Model: Bellini-C2/Martini-C2 Z-folding Unit Type2105	Date: 15-Oct-04	No.: MB660001
--	-----------------	---------------

Modified Article: Main Control Board		Prepared by: M. Matsuda	
From: 2nd Tech. Support Sec. Service Support Dept.			
Reason for Modification:	<input checked="" type="checkbox"/> Parts catalog correction	<input type="checkbox"/> Vendor change	<input type="checkbox"/> To meet standards ()
	<input type="checkbox"/> To facilitate assembly	<input type="checkbox"/> To improve reliability	
	<input type="checkbox"/> Part standardization	<input type="checkbox"/> Other

Model: Bellini-C2/Martini-C2 Z-Folding Unit	Date: 26-Apr-05	No.: MB660002a
---	-----------------	----------------

Modified Article: HORIZONTAL GUIDE PLATE		Prepared by: S.Ishizu	
From: 2nd Tech. Support Sec. Service Support Dept.			
Reason for Modification:	<input type="checkbox"/> Parts catalog correction	<input type="checkbox"/> Vendor change	<input checked="" type="checkbox"/> Other
	<input type="checkbox"/> To facilitate assembly	<input type="checkbox"/> To improve reliability	<input type="checkbox"/> To meet standards
	<input type="checkbox"/> Part standardization	<input type="checkbox"/> Product Safe

Old part number	New part number	Description	Q'ty	Int	Page	Index	Note
-	<i>B6601751</i>	<i>HORIZONTAL GUIDE PLATE: PF4132P142A</i>	1	-	5	*31

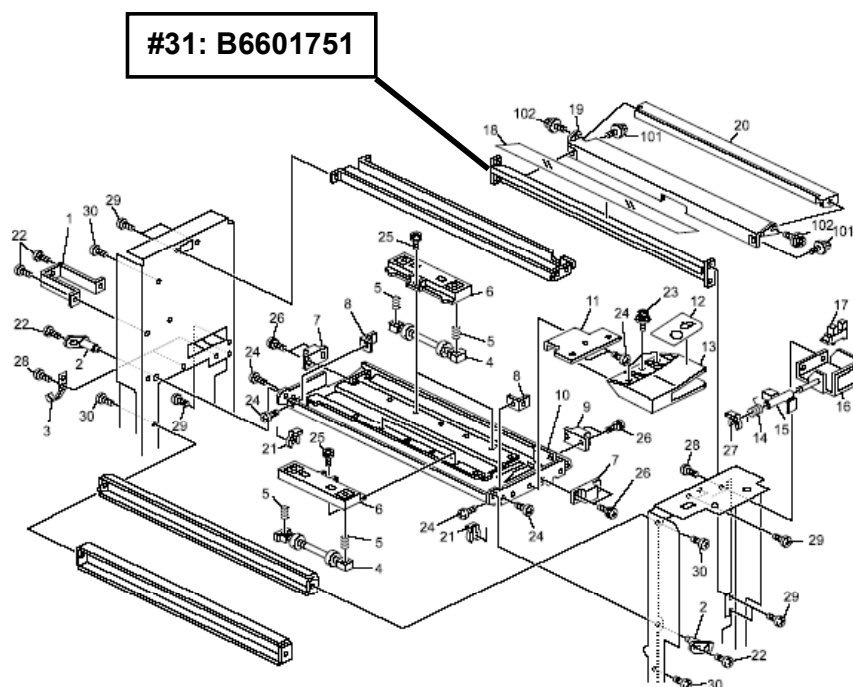
Change: This part was added.

Reason: A request from the field.
